# COMMUNITY DEVELOPMENT DEPARTMENT REPORT

HEARING 12/4/2025  
DATE:  
TO: Planning & Zoning Commission  
FROM: Nick Napoli, Associate Planner  
208-884-5533  
nnapoli@meridiancity.org  
APPLICANT: Brandon Sheltrown  
SUBJECT: H-2025-0020  
Lofty Creek Park

Rezone of 6.34 acres from the L-O zoning to the C-C and C-G zoning districts, a short plat to subdivide the property into two lots to allow for the phasing of the development, and a development agreement modification to remove multifamily as an allowed use and allow for live work residential units, office, and hotels on the property.

### C. Site Plan (date: 7/25/2025)

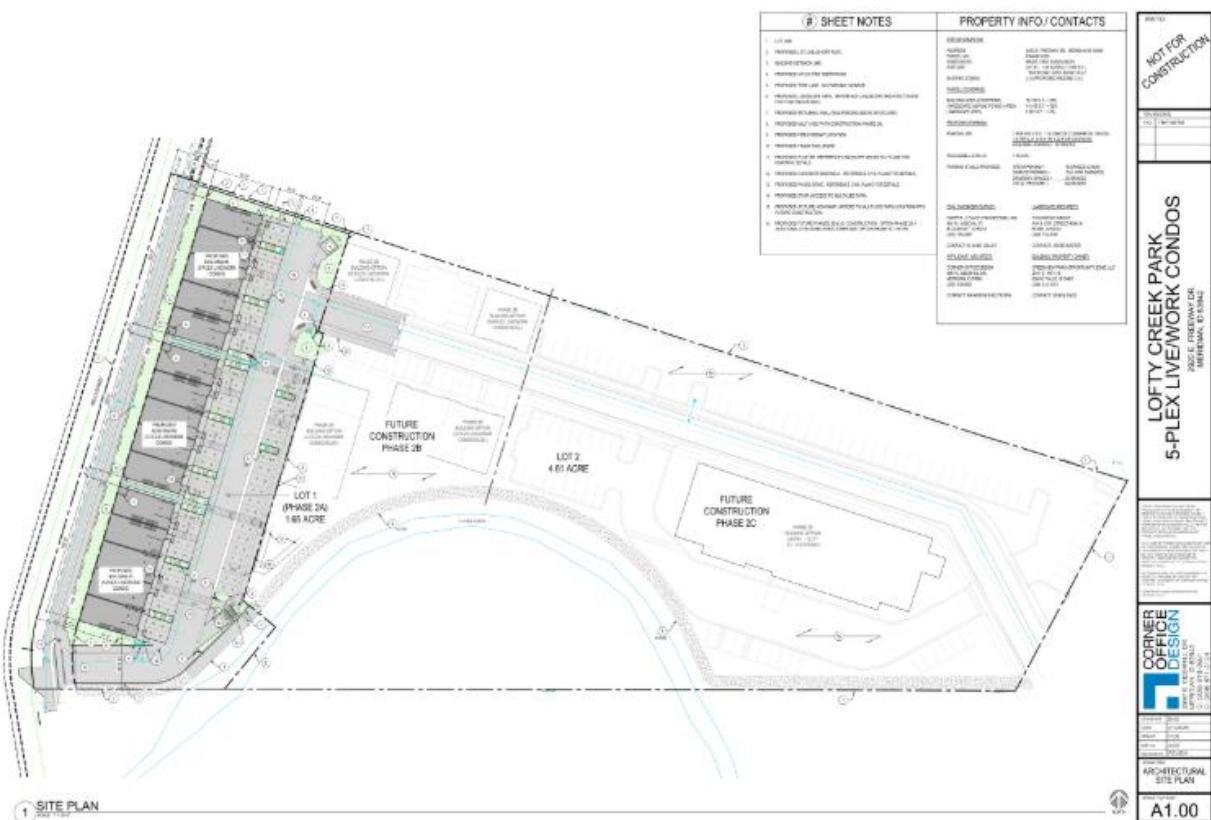
- Staff is recommending a change to the site plan to shift the access from the south portion of the site to the north portion of the site along S. Wells Avenue. This is primarily due to the offset of the property across S. Wells Street.

In addition, due to results from a traffic study being conducted by the city, staff is recommending the entrance for the development be shifted from the southern boundary to the northern boundary along Wells Street. This will allow for an adequate offset to where a future collector road could be placed.

Landscaping is required to be provided along all pathways per the standards listed in UDC 11-3B-12C. *The applicant does not meet the pathway landscaping requirements and shall revise their site and landscape plan to reflect compliance with these standards. A minimum of ten (10) feet of landscaping is required along pathways with no less than two (2) feet on any one side. Staff will require this with the submittal of the certificate of zoning compliance application.*

UDC 11-3C mandates one (1) bicycle parking space shall be provided for every twenty-five (25) proposed vehicle parking spaces or portion thereof, except for single-family residences, two-family duplexes, and townhouses. *The applicant did not propose and bicycle parking with this application but shall revise the site and landscape plans to show compliance with this standard.*

The city is currently in the process of conducting an RFQ to look at the traffic along E. Magic View Drive and E. Woodbridge Drive. This study has not been completed yet; however, it will analyze the best orientation for future roadways through the immediate area between Eagle Road and Locust Grove. **As a result of some of the preliminary findings from this study, staff recommends the primary entrance off of Wells Street be shifted to the northern boundary of the site to allow for adequate offset.**

- Construct a detached sidewalk with an 8-foot wide parkway adjacent to S. Wells Street in accord with the standards listed in UDC 11-3A-17 and UDC 11-3B-7C.

- Provide a pedestrian connection from the 10-foot multi-use pathway along Five Mile Creek to the live/work units on the west side of the private drive aisle that is delineated through bricks, pavers, or stamped/scored concrete.

- Provide bicycle parking for each building as required in UDC 11-3C-5.
  - Provide pathway landscaping in compliance with UDC 11-3B-12.
  - Add a plat note referencing cross-access between the separate lots in the subdivision.

#### **D. Landscape Plan (date: 7/25/2025)**

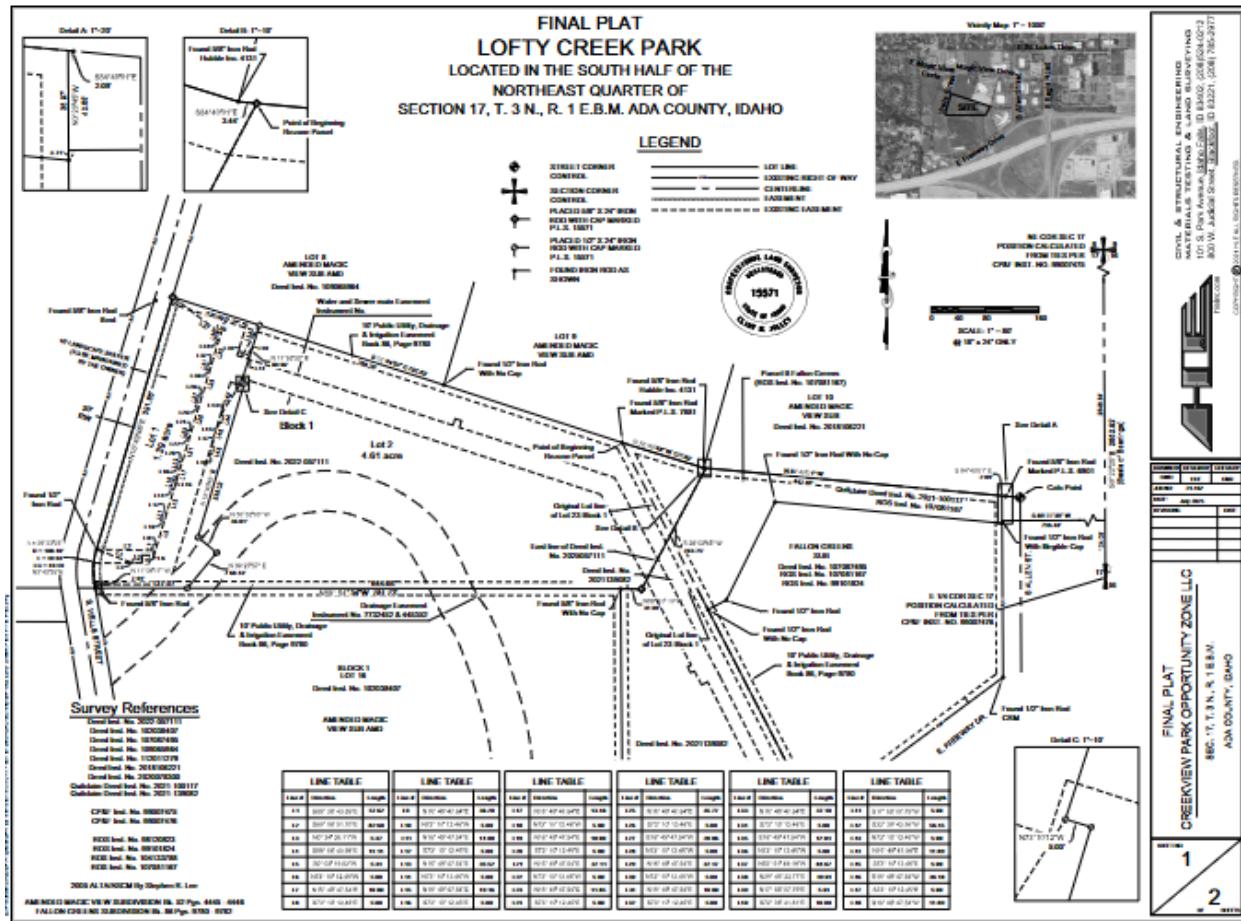
A ten (10) foot wide street buffer is required along S. Well Street, a local street. The landscaping within this buffer is required to be installed per UDC 11-3B. *The proposed landscape plan appears to meet this requirement. However, staff is requiring vegetation calculations to be submitted with the certificate of zoning compliance application.*

Landscaping is required to be provided along all parking areas per the standards listed in UDC 11-3B-8. *The proposed landscape plan appears to meet the minimum requirements. The applicant shall provide vegetation coverage calculations with the submittal of the certificate of zoning compliance submittal.*

- The 5-foot-wide landscape strips along pathways shall include a mix of trees, shrubs, lawn, and/or other vegetative ground cover as set forth in UDC 11-3B-12C; trees should be spaced out more evenly for shade purposes at approximately one (1) every 100 linear feet, additional trees beyond the minimum number may be provided.

- Include a calculations table that demonstrates compliance with the standards for landscaping within street buffers (UDC 11-3B-7C), along pathways (UDC 11-3B-12C) and within common open space areas (UDC 11-3G-5B).
